UNITED STATES PATENT AND TRADEMARK OFFICE

APPLICATION NO.	FILING DATE	FIRST NAMED INVENTOR	ATTORNEY DOCKET NO.	CONFIRMATION NO.
09/965,946	09/26/2001	Ronald E. Mizia	B-076	3356

Office Action Summary

DETAILED ACTION

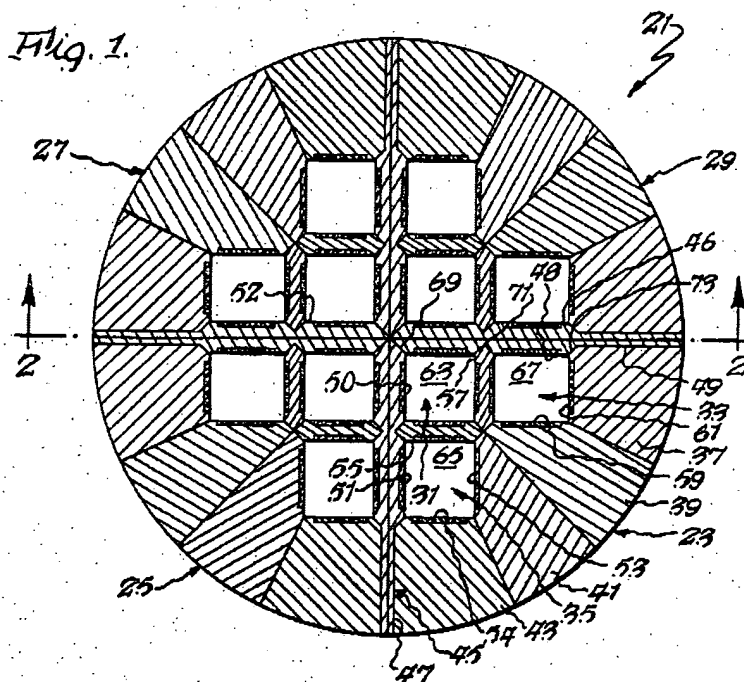
Regarding the teaching of austenitic steel, the examiner applied the obviousness test from the flowchart in MPEP § 2144.08 (shown in the Appendix of this Office Action). Following the flowchart, the answers are as follows:

II.A.4a.	No
II.A.4b.	No
II.A.4c.	Yes
II.A.4d.	Yes

It would have been obvious to one with ordinary skill in the art at the time the invention was made that the steel of Fujiwara could have austenitic properties, since the *Metals Handbook*, 10th

Shaffer teaches a cask for radioactive material such as spent nuclear reactor fuel (see Figure 1 below).

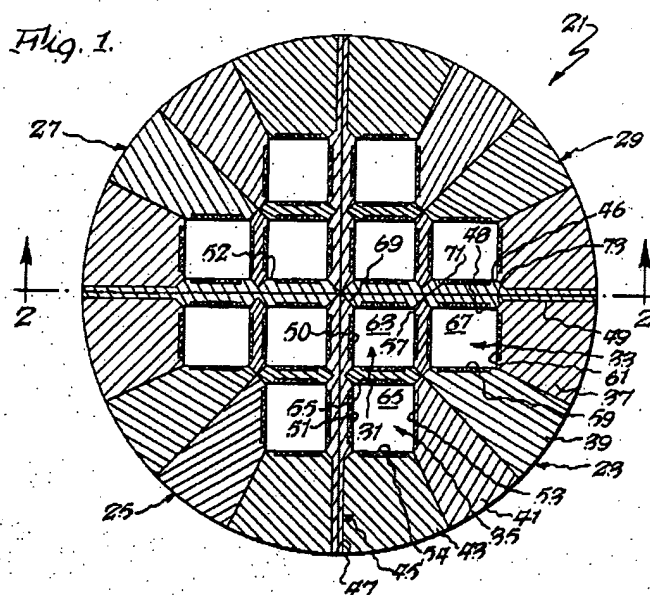
The walled internal compartments 31, 33, and 35, absorb neutrons (column 1, lines 60 and 61; column 2, lines 64 and 65). Compartment walls 55 and 57 have parts that serve as bearers of

neutron-absorbing material (column 2, line 67 to column 3, line 7). Regarding the parts of Claims 9 and 10, it would have been obvious to one with ordinary skill in the art at the time the invention was made that the stainless steel taught by Kajimura could be used in the cask components of Shaffer, since Shaffer teaches that the cask material could be made from stainless steel (Shaffer, column 7, lines 7-24). Also, Kajimura meets the requirement in Shaffer (column 7, lines 20 and 21) for corrosion resistance.

Shaffer teaches a cask¹ for radioactive material such as spent nuclear reactor fuel (see Figure 1 below).

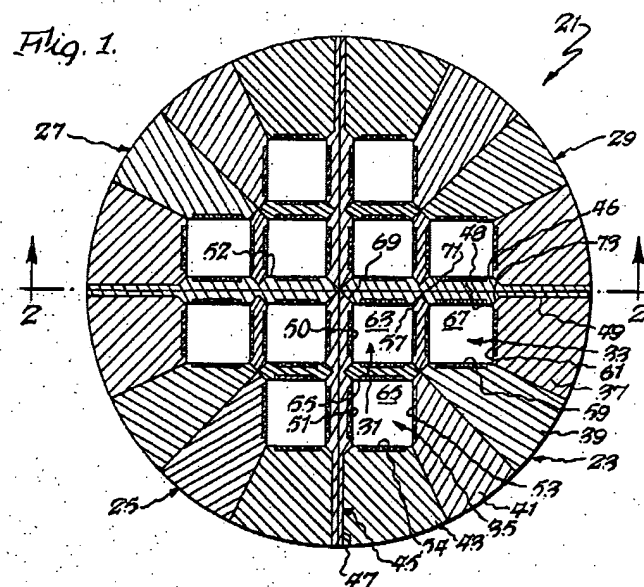
The walled internal compartments 31, 33, and 35, absorb neutrons (column 1, lines 60 and 61; column 2, lines 64 and 65). Compartment walls 55 and 57 have parts that serve as bearers of neutron-absorbing material (column 2, line 67 to column 3, line 7). Regarding the parts of Claims 9 and 10, it would have been obvious to one with ordinary skill in the art at the time the invention was made that the stainless steel taught by Fujiwara could be used in the cask components of Shaffer, since Shaffer teaches that the cask material could be made from stainless steel (Shaffer, column 7, lines 7-24). Also, Fujiwara meets the requirement in Shaffer (column 7, lines 20 and 21) for corrosion resistance.
